1 INTRODUCTION

- 1.1.1 Prime Transport Planning (Prime) has prepared this Technical Note (TN) on behalf of Gladman Developments Ltd (Gladman) to support its:

‘Outline planning application for the erection of up to 158 dwellings (all matters reserved except access).’

APPENDIX A

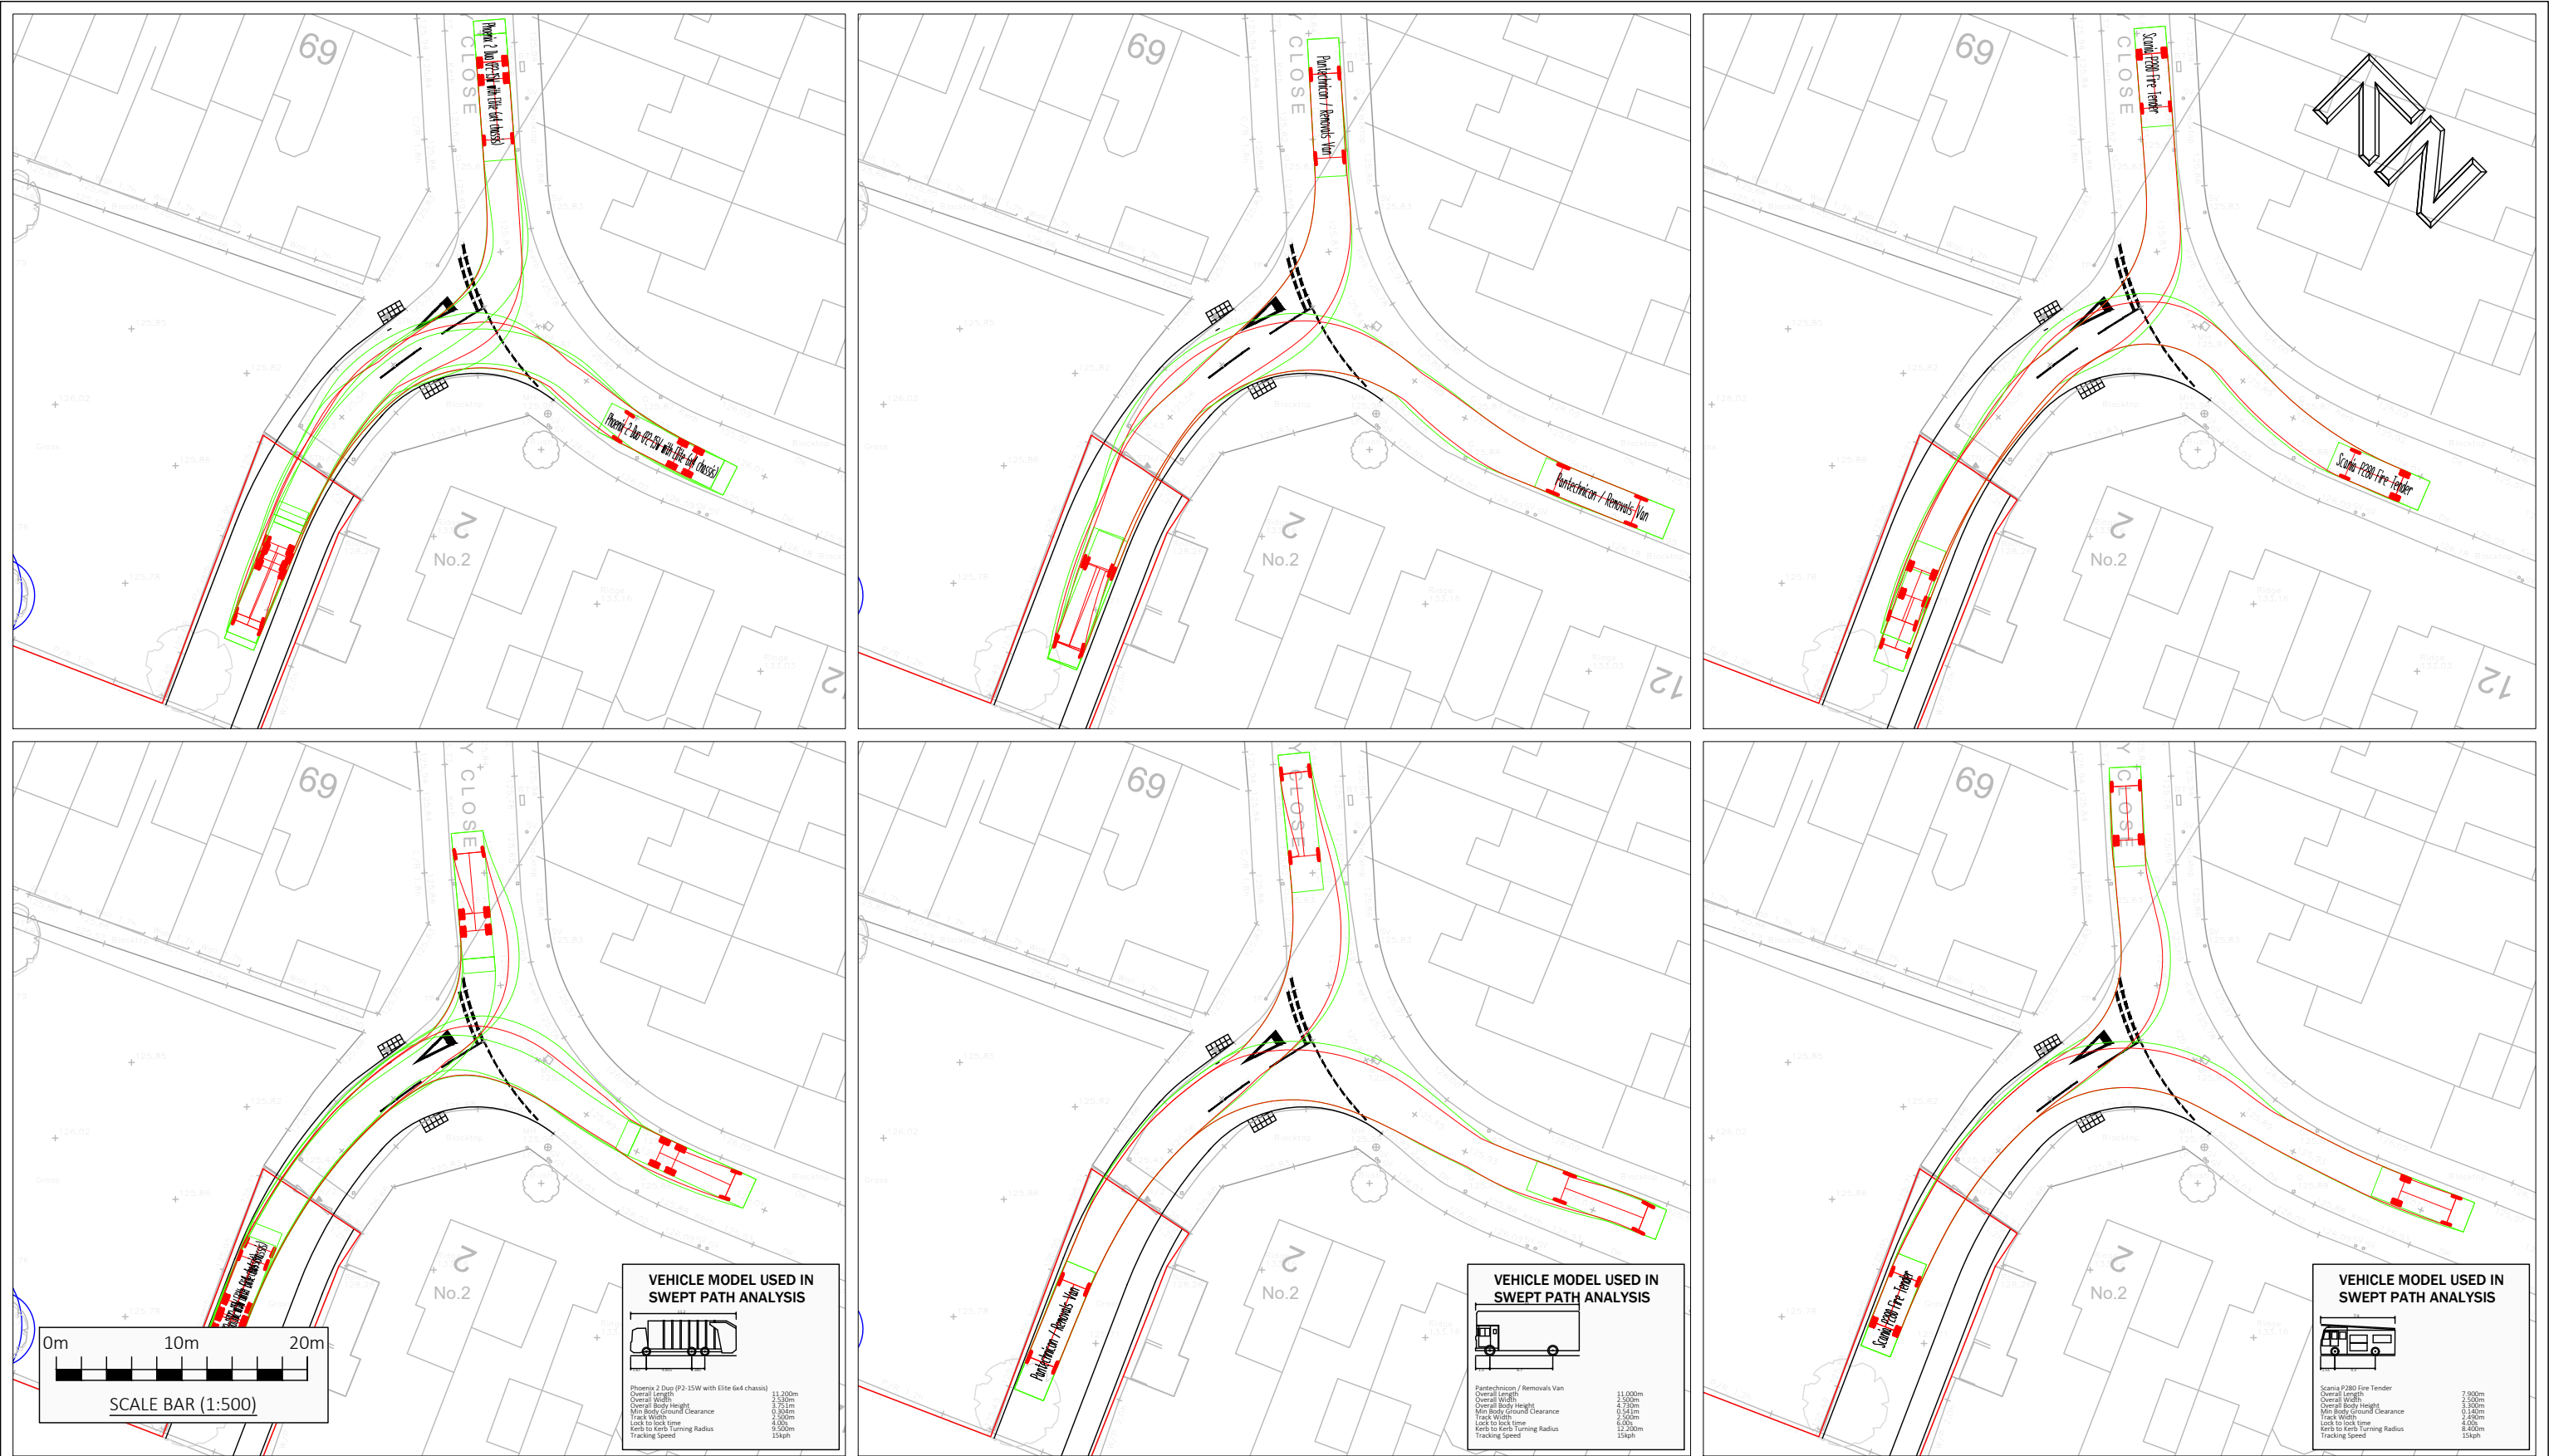
'The Applicant has stated swept path analysis of a refuse collection vehicle is provided on the site access drawing, however this appears to have been omitted from the drawing. The LHA therefore requests the swept path analysis. It should be noted the dimensions (at least 11.2m) and speed of the vehicle (15KPH) are provided on the drawing.'

- 2.3.3 The swept path analysis (SPA) for an 11.2m refuse collection vehicle is shown on Drawing P25081-004 in Appendix C of this TN, which demonstrates that the vehicle can safely enter and exit the site in forward gear. The Drawing also confirms that the SPA has been undertaken at a vehicle speed of 15kph.

- 2.3.4 For robustness, two additional SPAs have been undertaken for a pantechicon and a fire appliance. These are illustrated on Drawing P25081-004 in Appendix C of this TN and demonstrate that both vehicles can safely enter and exit the site in forward gear.

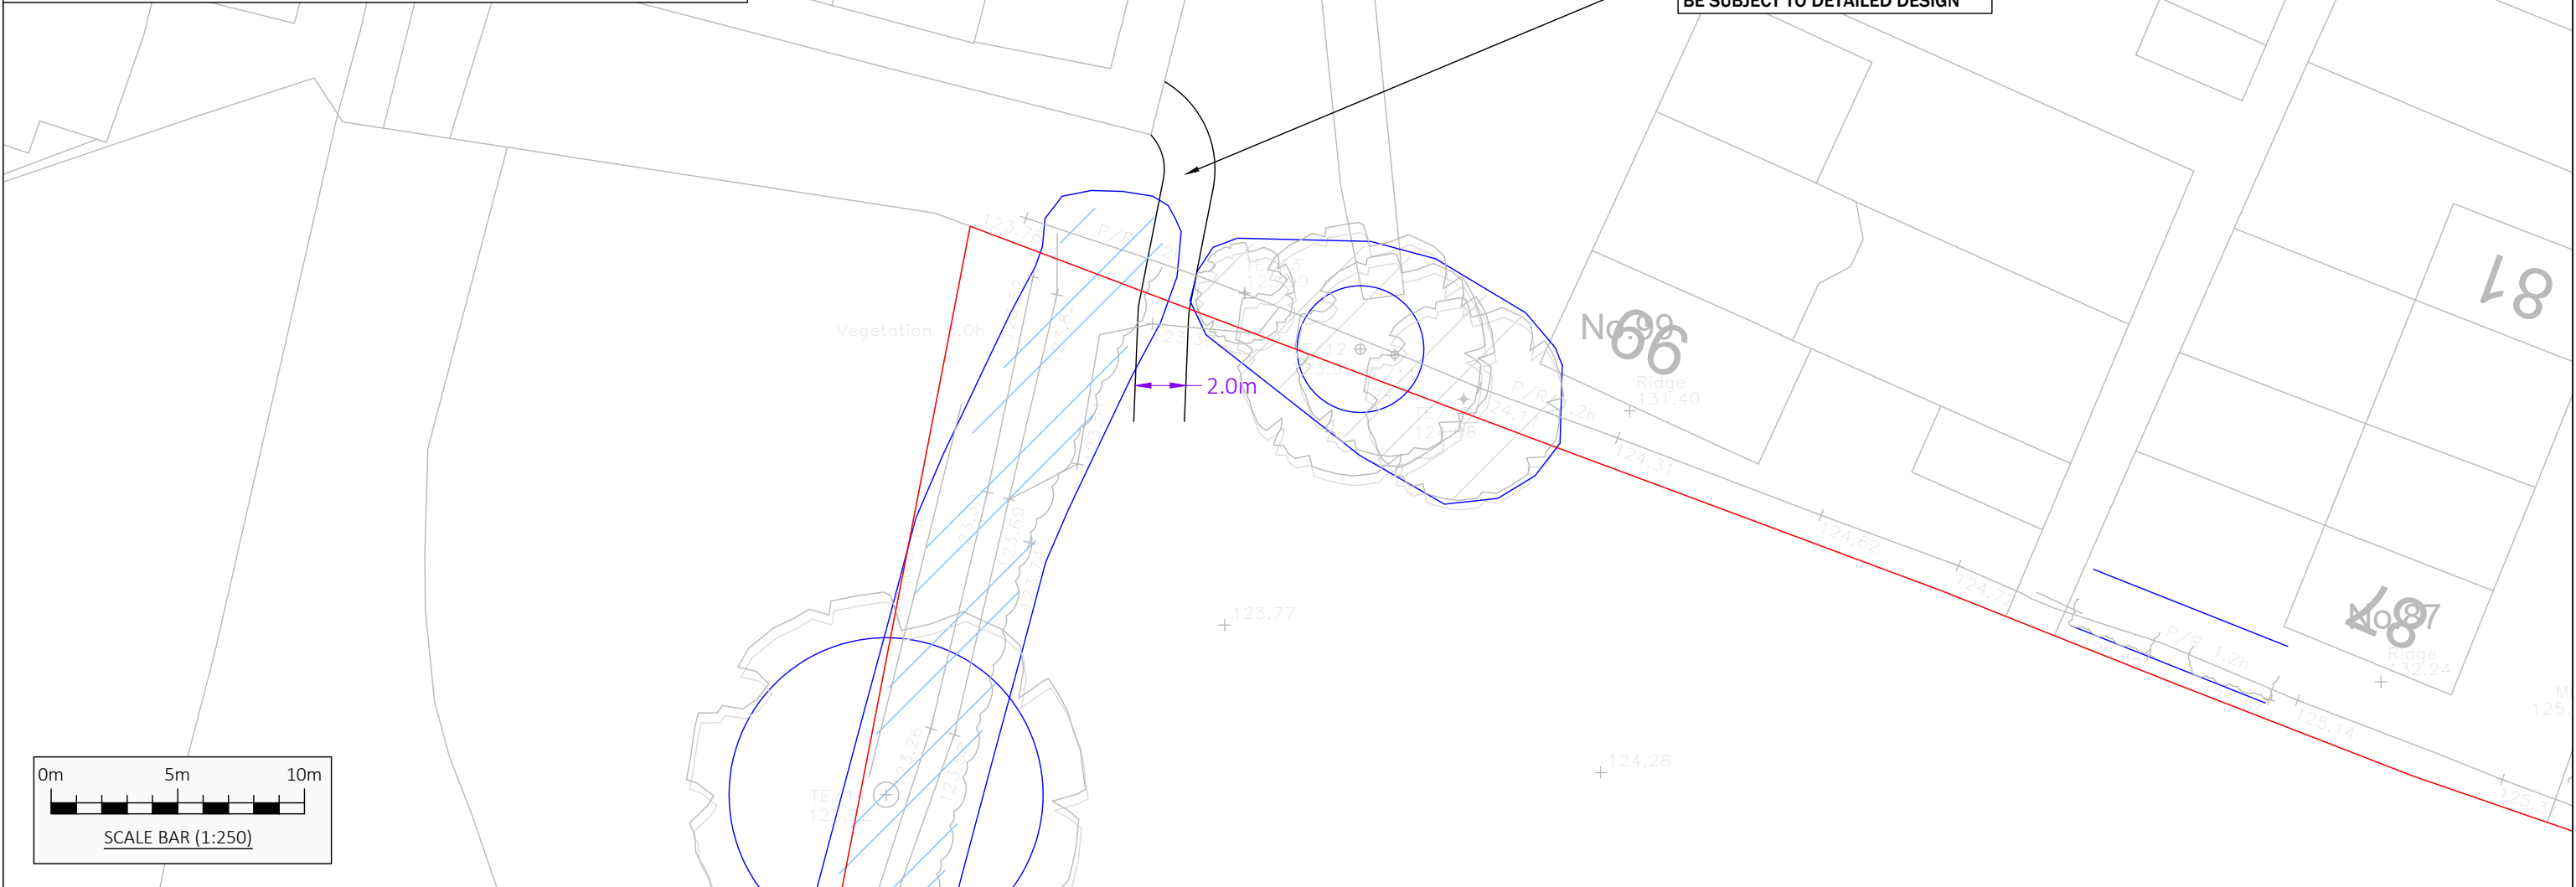
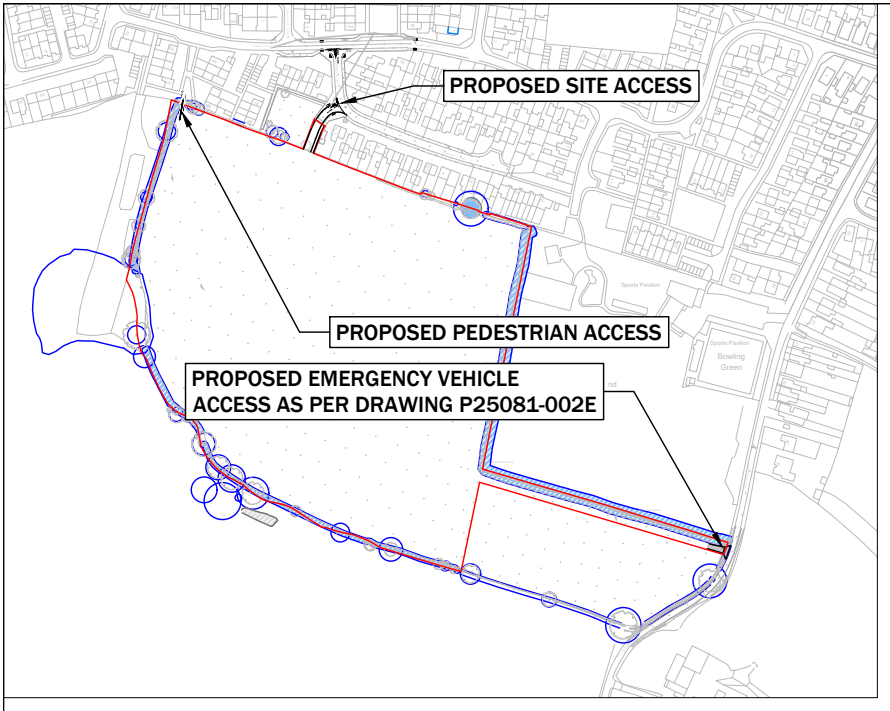
'As well as the main site access Cunnery Close, the Applicant is proposing a dedicated pedestrian access point in the north-western corner of the site, providing access to Manor Road via an existing footpath. Based on available records, the existing footpath and verges form part of the adopted highway. A drawing detailing the link has not been provided however, and this would be welcomed.'

2.4.3 A drawing illustrating the proposed pedestrian link utilising highway land has been produced and is shown on Drawing P25081-003 in Appendix C of this TN. It should be noted that the arrangement shown is illustrative at this stage and will be subject to detailed design.

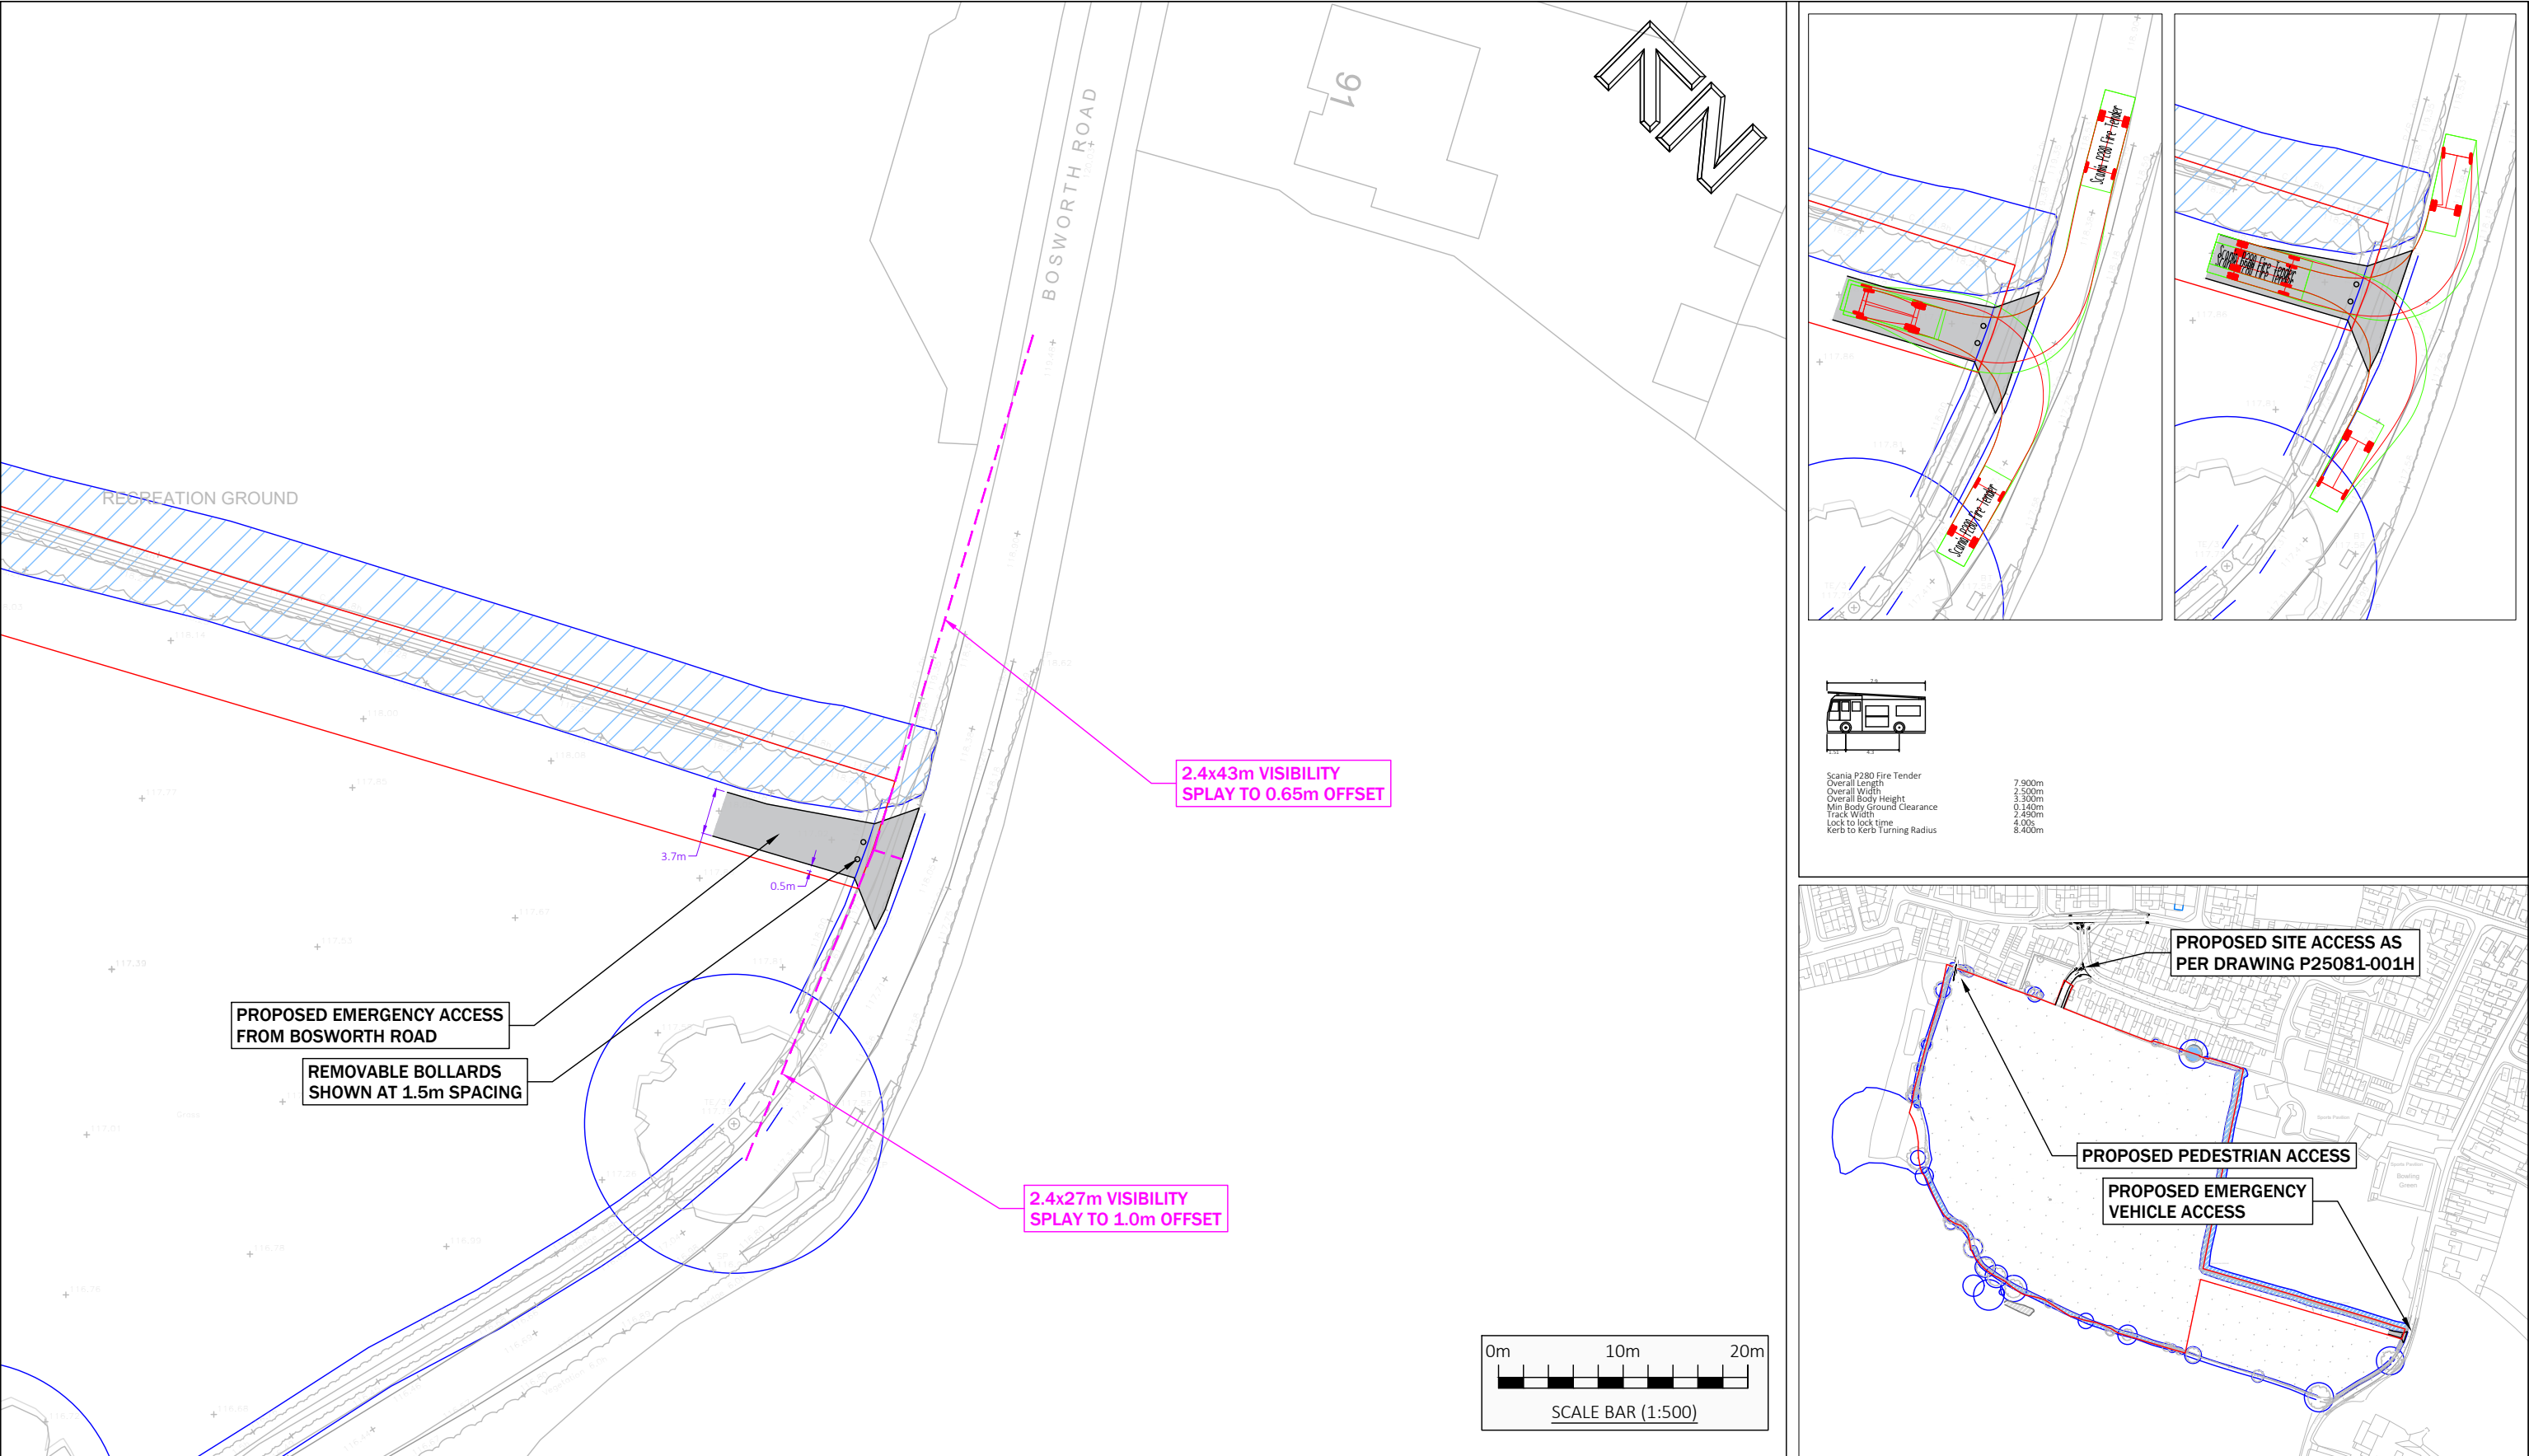
'The LHA advises that visibility splays have not been demonstrated at the access and following a site visit, these are likely to be minimal due to the existing hedgerow and bend in the road. The dimensions of the fire tender used as well as the design speed used has not been demonstrated. Swept path analysis would need to be shown in all directions for a 11.2m length refuse vehicle, pantechnicon, and fire appliance.'

'The LHA advise based on Table 6 of the LHDG, visibility splays of 2.4 x 43m would be required in each direction at the access and need to be demonstrated on the drawing. Currently it is unclear whether such splays could be achieved within land under the Applicants control and/or the highway boundary.'

2.5.5 That said, Prime has investigated the level of visibility that can be achieved from the emergency access. To the left on exit, an LCC requested visibility splay of 2.4m x 43m can be achieved with a 0.65m offset from the carriageway edge. To the right on exit, a visibility splay of 2.4m x 27m can be

- achieved with a 1.0m offset from the carriageway edge. All visibility splays are shown on Drawing P25081-002E in Appendix C of this TN and can be delivered within the red line boundary and adopted highway. It is important to note that the LCC LHDG permits an offset of up to 1.0m for visibility splays.

- 2.5.9 As requested, the dimensions of the fire appliance have been added to Drawing P25081-002E in Appendix C of this TN.
- 2.5.10 Prime considers the SPA of a refuse collection vehicle and pantechnicon at the emergency access to be unnecessary. The access would be gated and restricted solely to emergency vehicles and would not be available for general vehicular access or servicing activities. Refuse collection and delivery vehicles would therefore have no requirement to use the emergency access, with all servicing and refuse collection movements instead accommodated via the main vehicular access.
